DIXIE-MARCO, INC.
SERVICE BULLETIN #106

Date: April 21, 1970
Revised January 20, 1971

MODELS AFFECTED: Seventies Series Serpentine With
Plastic Coin Reject Assembly.
DN175-5, DN225-5 and DN300-5

REASON: To provide a replacement Reject Assembly as Customer
Location dictates.

INSTRUCTIONS FOR INSTALLATION
OF REPLACEMENT METAL BUTTON

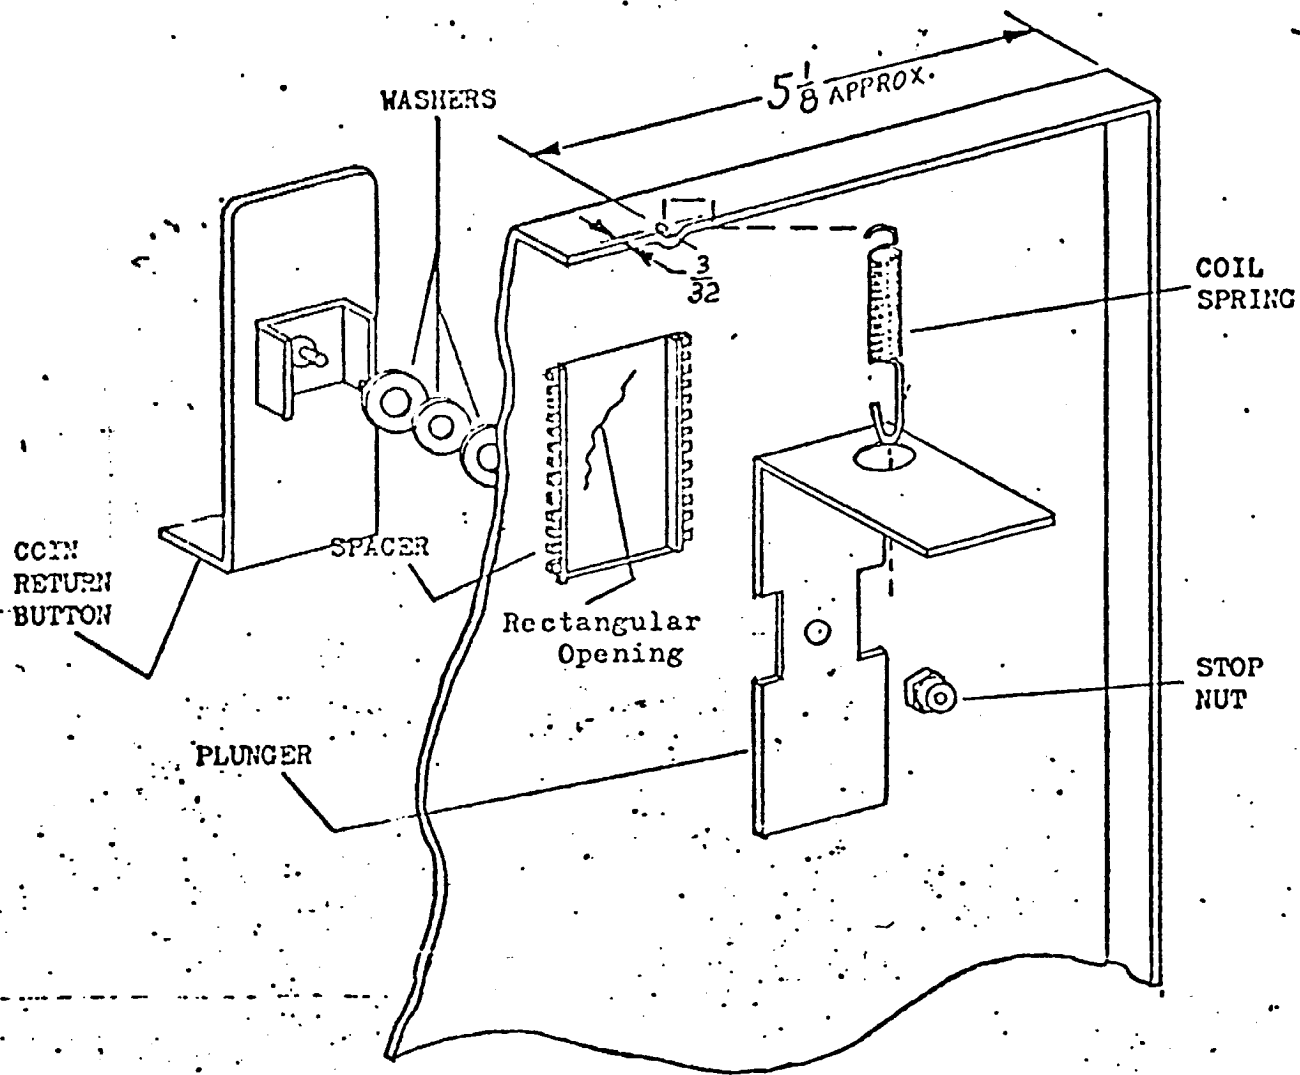
On some locations where the Plastic Coin Reject Assembly does
not "hold up" when subjected to rough useage, the Kit outlined
below will correct the problem.

1. REMOVE PLASTIC BUTTON, PLUNGER, AND NYLON STRIPS.
2. DRILL A 1/16" HOLE AS SHOWN, DEPRESSING FLANGE AT HOLE TO PREVENT SPRING FROM RUBBING.
3. FILE THE METAL AWAY FROM THE SIDES OF THE RECTANGULAR OPENING IF THE OPENING IS TOO SMALL. THE WIDTH SHOULD BE ONE (1) INCH OR SLIGHTLY OVER.
4. ASSEMBLE BUTTON AS SHOWN AND ATTACH SPRING.
